Re: 1155-1173 Hearst Avenue/ZP2016-0028 Response to March 2, 2017 Incomplete Letter

### DRAFT TECHNICAL MEMORANDUM

Terraphase Engineering Inc. (Terraphase) has prepared this technical memorandum based on our review of the Stormwater and Flooding Assessment and Mitigation Design for the Hearst Avenue Project 1161-1173 Hearst Avenue, Berkeley, California. Terraphase appreciates the thorough assessment and preliminary design prepared Clearwater Hydrology. The document is well-researched, clearly written, and we are in general agreement with many of the report findings. However, in the following sections, Terraphase has provided selected excerpts of the document for which we have questions, concerns or suggestions and where we feel additional information or analysis is needed.

-(A1.2)

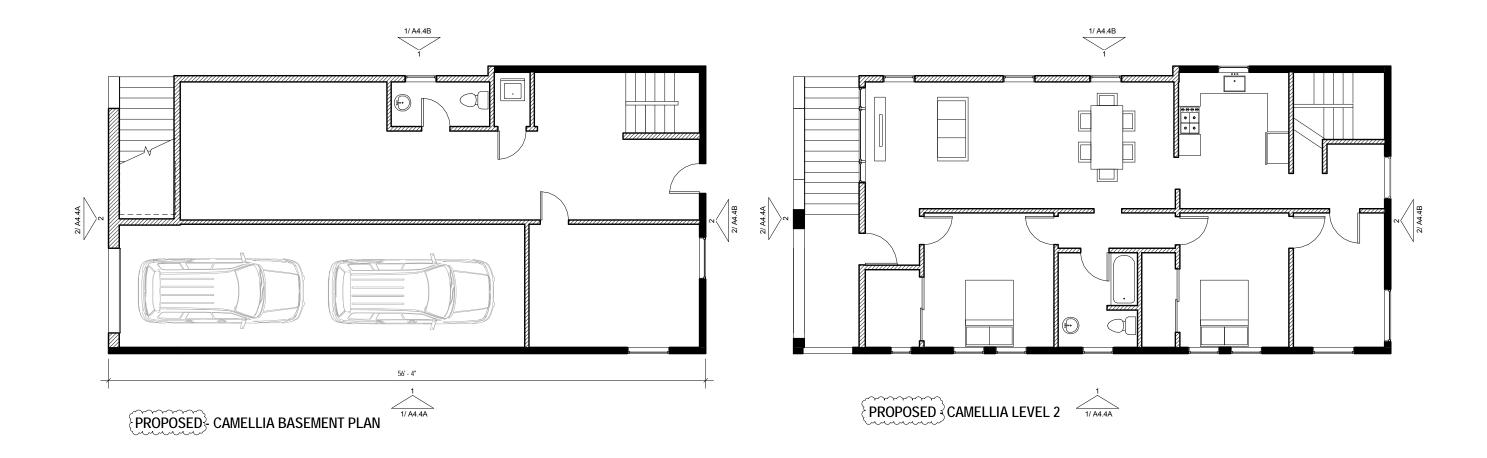
Floor Plans – Label the existing and proposed ground floor of Camelia on pages A.1.2
 A4.4; and Azalia and Begonia Level 1 on page A4.2. To expedite this submittal (and project completeness), feel free to resubmit just these pages and not the whole plan set.

Floor Plans – Label <u>ALL</u> existing and proposed ground floor <u>rooms</u> of Camelia on pages A.1.2 A4.4; and Azalia and Begonia Level 1 on page A4.2. To expedite this submittal (and project completeness), feel free to resubmit just these pages and not the whole plan set.

- Please see attached Page A1.2 showing the existing conditions of the Camelia building. Please see Page A4.4 showing the proposed floor plans for the Camelia building. Page A1.2 only shows the existing Camelia floor plan and Page A4.4 only shows the proposed Camelia floor plans.
- Please see attached Page A4.2 showing the proposed floor plans for the Azalea and Begonia Buildings. The existing floor plans for the Azalea and Begonia buildings can be found on Page A1.1 of the plan set submitted on January 31, 2017.

Figure 2: Northside Hearst Avenue Sub Watersheds

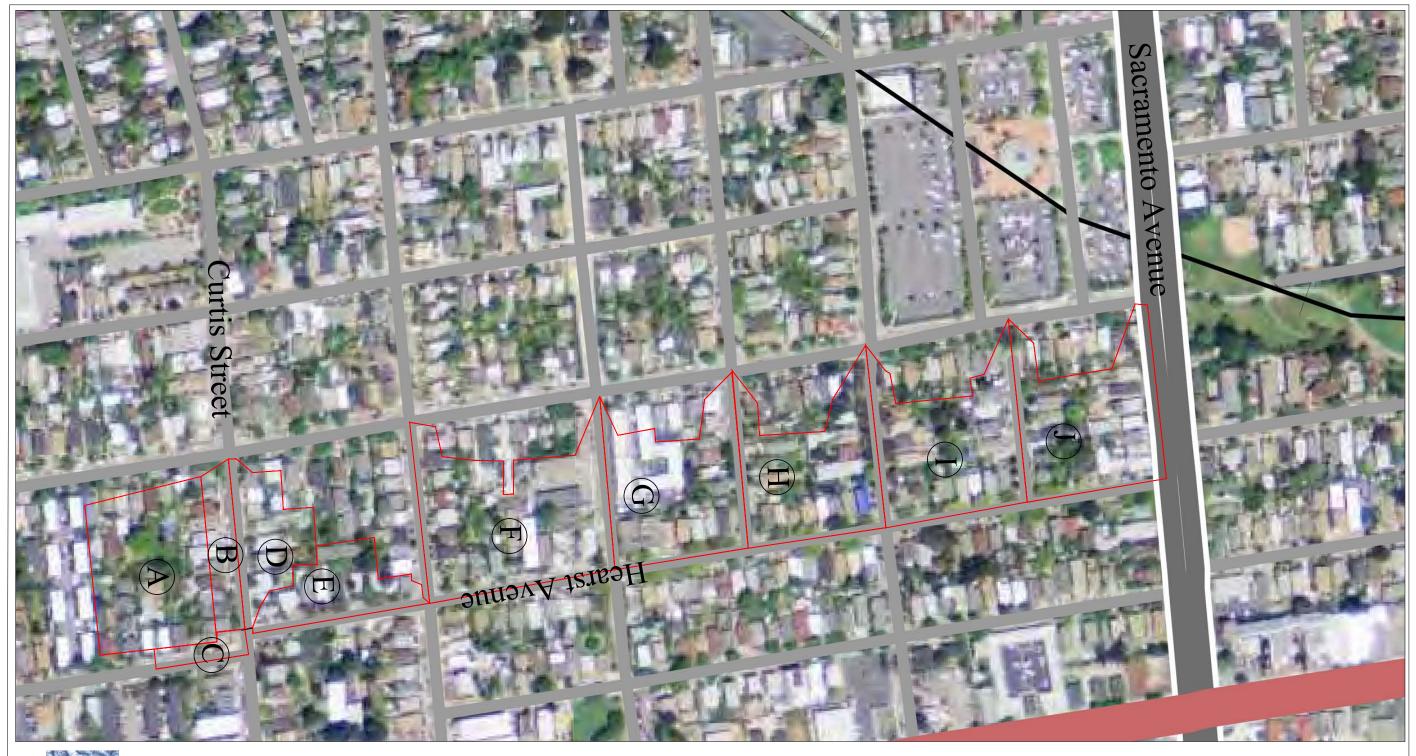
- o It would be helpful to provide the referenced estimated peak discharge rates here and cross-reference the full listing of peak discharge rates that can be found in Table 1 (although the first line item for Sub-Watershed A is blank).

- o Please clarify how the peak discharges from the gutters were added to watershed A?
- ❖ Table 1 is missing the peak discharge rates for Sub-Watershed A

- Please clarify how Watersheds A and B were accounted for in the flow modeling.
     Provide additional information for Sub-watershed B flow conditions.

- b. A North Arrow and label for Curtis Street should be added to all figures for reference.
  - c. Clearwater should delineate the topographic depression area (a rough outline) on the figures.

Figure 8: Proposed Drainage Improvements

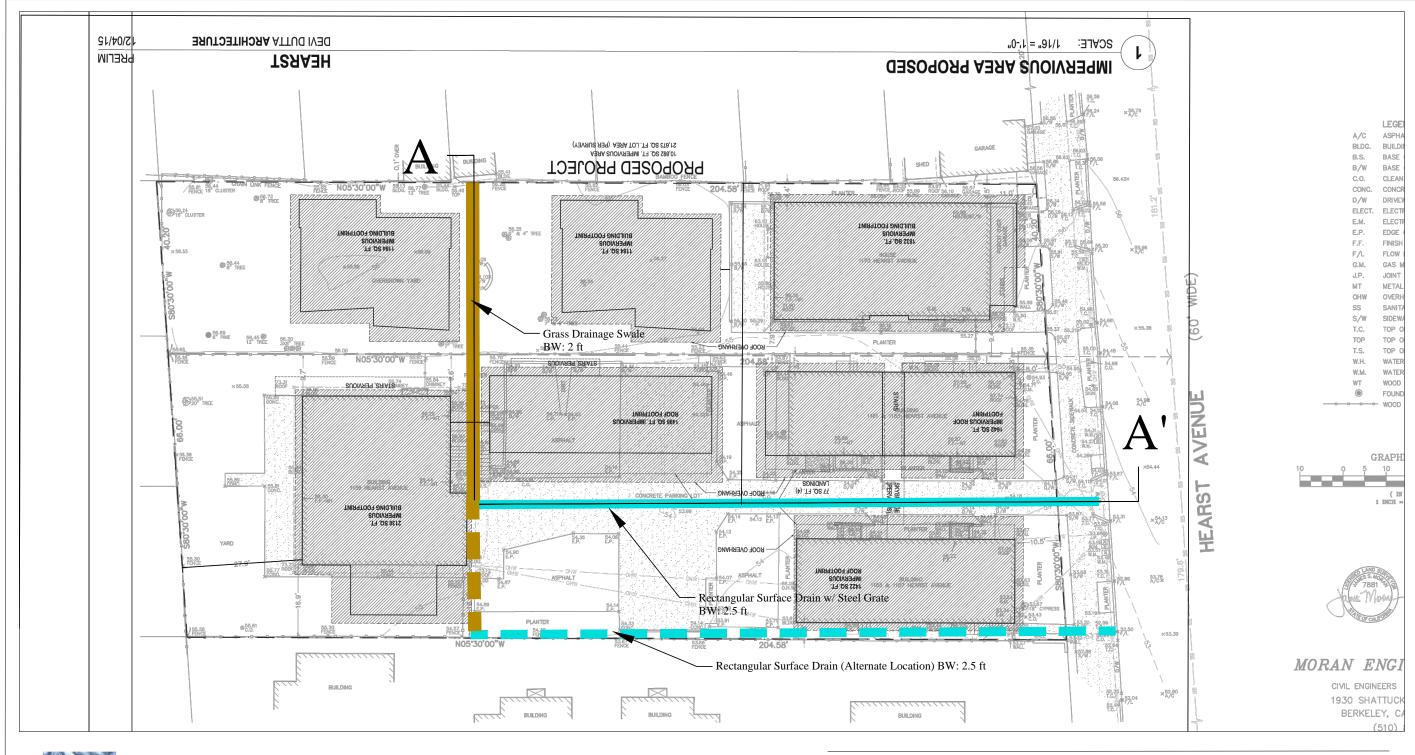
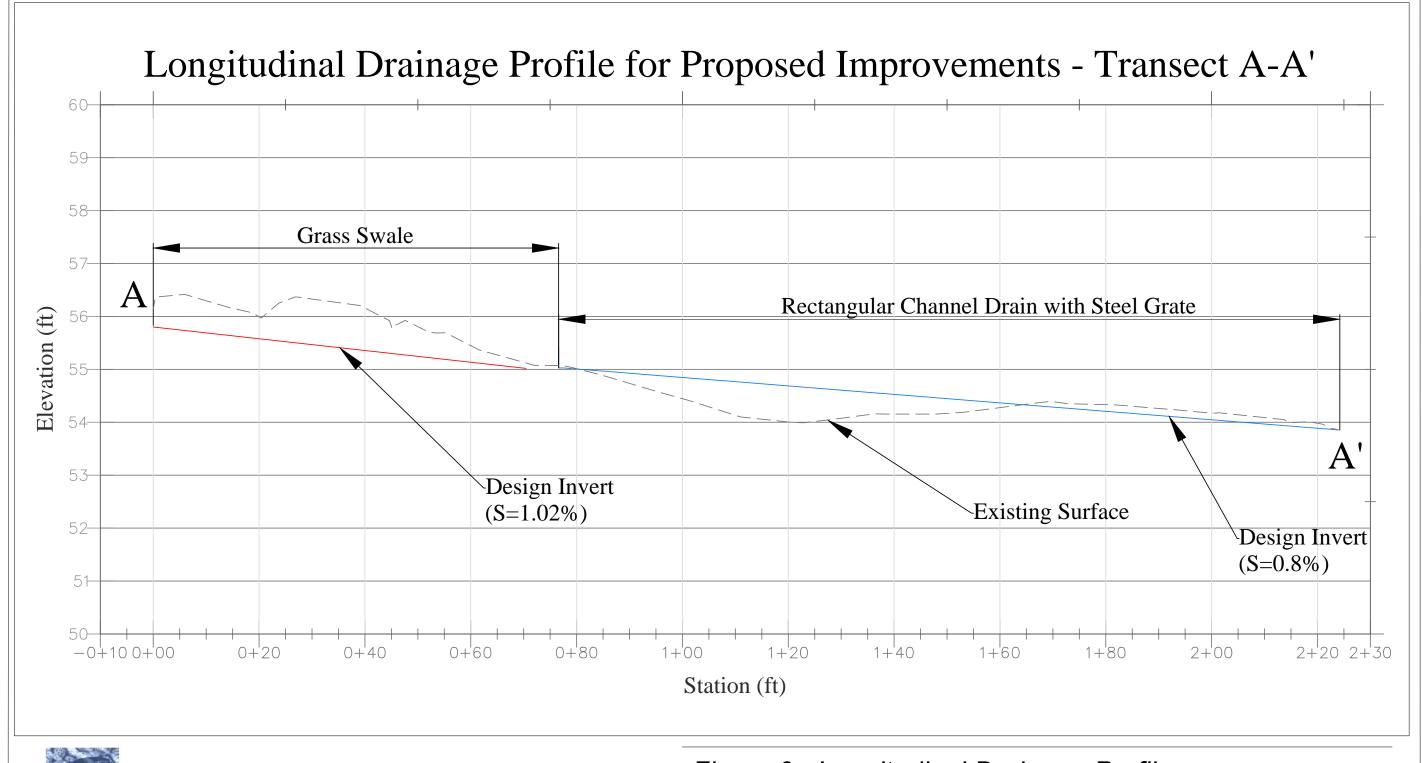
- o Assuming that everything is routed to the proposed channel, please clarify how the channel will collect flow from the adjacent properties.
  - o The design could be expanded to include a collection trench or sub-drain behind all of the houses to direct water into the proposed rectangular channel.

actual final design and detail for the outlet, it will work better all around to use the alternative alignment along the western property line. We've added that alignment to the plan view of both the alignments in Fig. 8.

A plan view of the proposed rectangular channel alignment is shown in Figure 8. Also noted on that figure is a connecting grassed swale that would extend eastward from the northern edge of the new parking lot to the eastern property line. This swale would have a minimum depth of 0.3 ft., which at that point along the property line would give it an invert elevation of approximately 55.8 feet. According to the Moran project topo data, the lowest surveyed rear yard elevation at the property line was 55.28 feet. As noted previously, the lowest breakover point in the back yard of 1173 Hearst is about 56.3 feet. Thus, the proposed grass swale depicted on Figure 8 would allow some drainage of floodwater to occur 0.5 ft. lower than it does under the current conditions. This should reduce the severity of flooding along the west side Curtis St. properties, although it will not alleviate the condition entirely. Figures 9 and 10 depict the longitudinal profile and typical cross-sections for the design solution shown in Figure 8.
